STAFF REPORT
KETCHUM PLANNING AND ZONING COMMISSION
REGULAR MEETING OF OCTOBER 13, 2020

- PROJECT:** Decked Building Addition
- FILE NUMBERS:** P20-078
- APPLICATION TYPE:** Design Review
- REPRESENTATIVE:** C. Michael Barker, Architect
- OWNER:** 345 Lewis LLC

- REQUEST:** Design Review for a proposed 1,825-square-foot, 25-foot tall addition to the Decked Building
- LOCATION:** 345 Lewis Street (Northgate Subdivision: Block 1: Lot 15)

Figure 2: Proposed West Elevation
(Project Plans Sheet A-1)

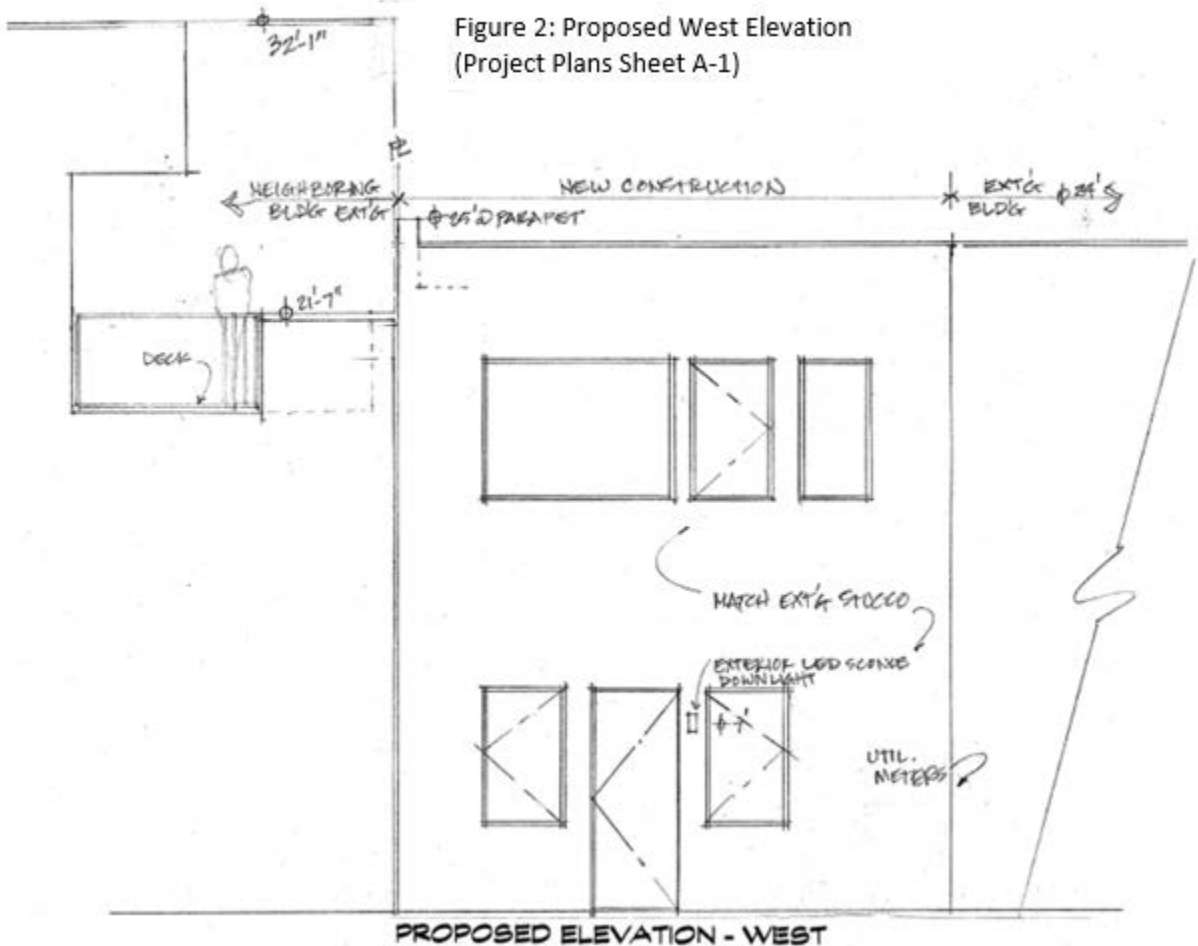
Light industrial buildings border the property to the east, north, and south along Lewis Street and Northwood Way. The addition project's materials, colors, and signing complement neighboring buildings in the light industrial area. The proposed 25-foot tall addition extends 19 feet north to the interior side property line shared with the Roth Building Condominiums located at 401 Lewis Street. The addition project complies with the dimensional standards required in the LI-2 Zone—buildings in the light industrial area may be built all the way up to interior side property lines and the maximum allowable building height is 35 feet. The proposed addition's parapet wall will extend 3'-3" above an existing second-floor deck located on the southside of the Roth Building. Pursuant to Ketchum Municipal Code 17.96.050.B, the Planning & Zoning Commission may add conditions of approval to projects to minimize adverse impact on other development. Staff recommends the Commission consider the impact of the proposed addition to the adjacent second-level deck.

SHEET: A-1
DATE: 8, 17, 20

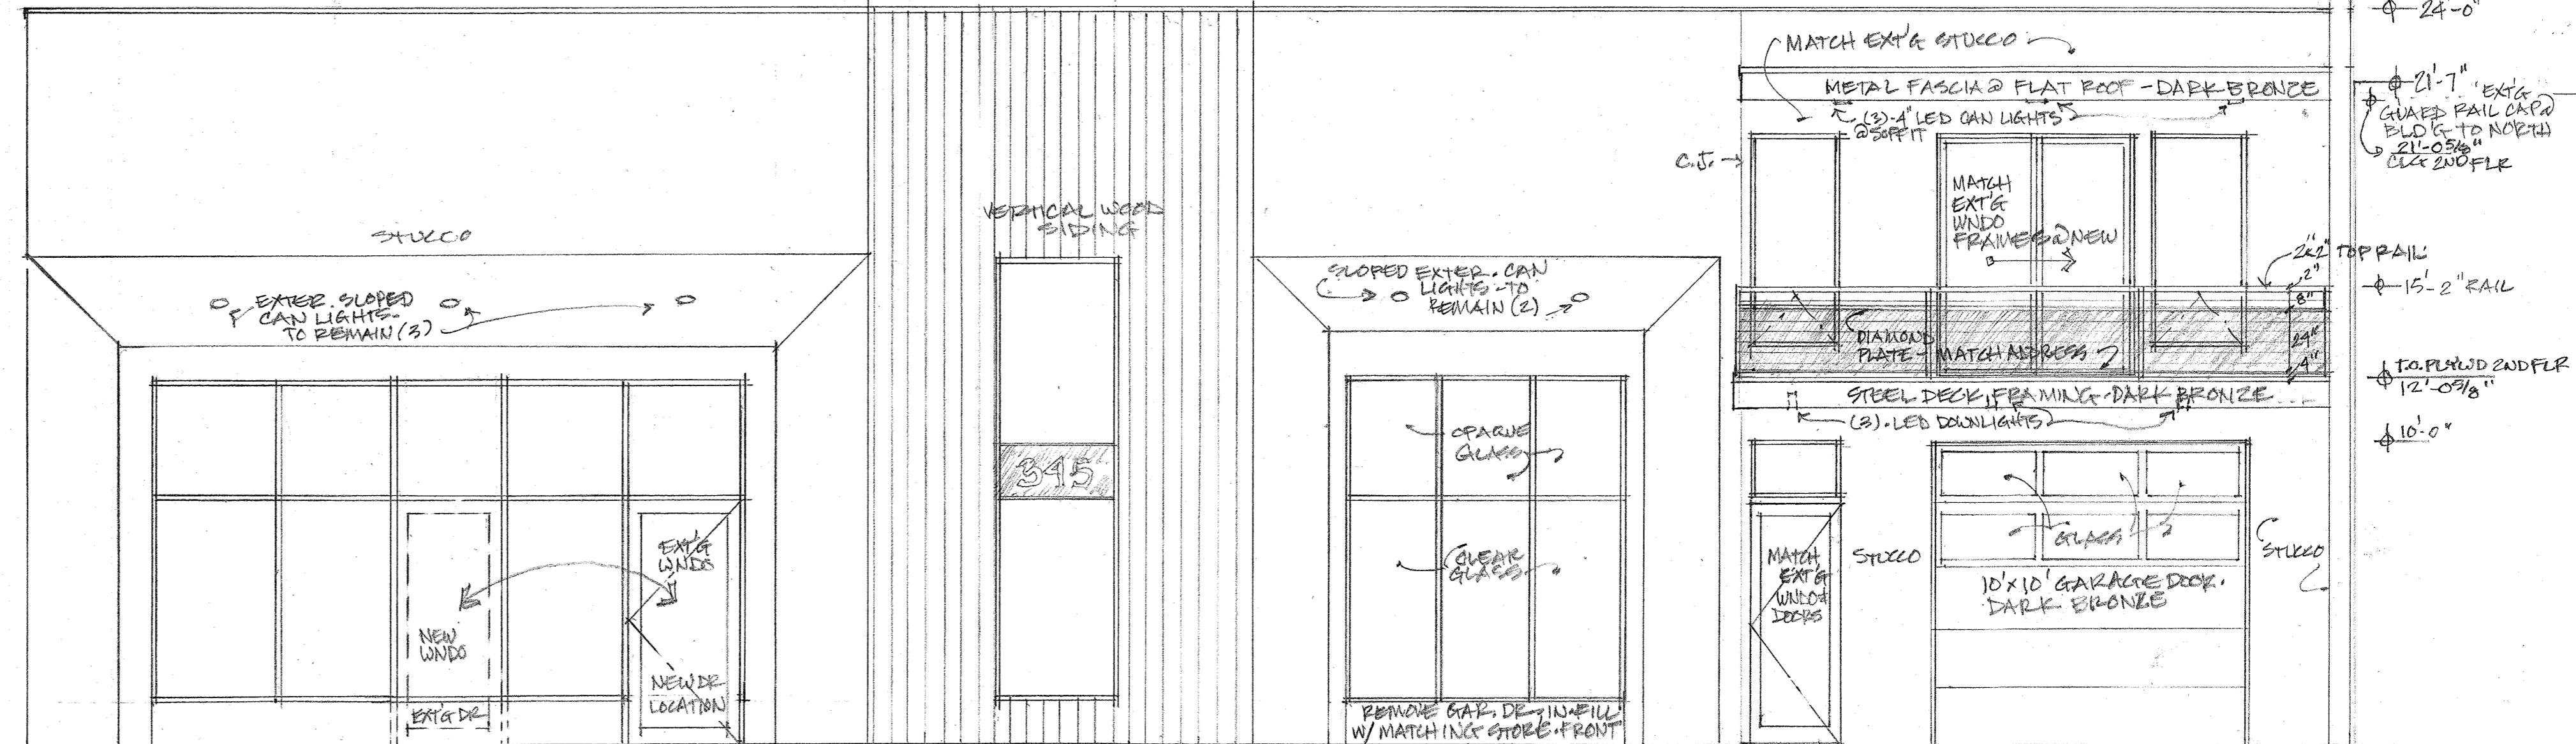
<input checked="" type="checkbox"/>	<input type="checkbox"/>	<input type="checkbox"/>	17.96.060.D2	Utilities shall be located underground and utility, power, and communication lines within the development site shall be concealed from public view.
			Staff Comments	All utilities within the development site shall be underground and concealed from public view. Sheet A-1 of the project plans indicates that utility meters

will be installed at the rear of the addition behind the existing Decked Building. Prior to issuance of a Certificate of Occupancy for the project, Planning & Building Department Staff will conduct an inspection to ensure that all utilities are concealed from public view. See above Staff comment for Ketchum Municipal Code §17.96.060(D)(1).
<input checked="" type="checkbox"/>	<input type="checkbox"/>	<input type="checkbox"/>	17.96.060.D3	When extension of utilities is necessary all developers will be required to pay for and install two (2") inch SDR11 fiber optical conduit. The placement and construction of the fiber optical conduit shall be done in accordance with city of Ketchum standards and at the discretion of the City Engineer.
			Staff Comments	The applicant is aware of this requirement and will comply with these standards.
<input checked="" type="checkbox"/>	<input type="checkbox"/>	<input type="checkbox"/>	17.96.060.E1	The project's materials, colors and signing shall be complementary with the townscape, surrounding neighborhoods and adjoining structures.

Staff Comments	As noted on Sheet A-1 of the project plans, the addition's exterior materials will match the existing building. The two-story addition matches the scale of the existing building with consistent dimensions and box-shaped building form.
<input checked="" type="checkbox"/>	<input type="checkbox"/>	<input type="checkbox"/>	17.96.060.F1	Building(s) shall provide unobstructed pedestrian access to the nearest sidewalk and the entryway shall be clearly defined.
			Staff Comments	The existing building is setback 43 feet from the front property line along Lewis Street. The addition will add an additional entrance to the Decked Building. The building entrances are defined by overhanging elements. The addition project includes a dark bronze steel deck that extends over the entrance to the new addition.
<input checked="" type="checkbox"/>	<input type="checkbox"/>	<input type="checkbox"/>	17.96.060.F2	The building character shall be clearly defined by use of architectural features.
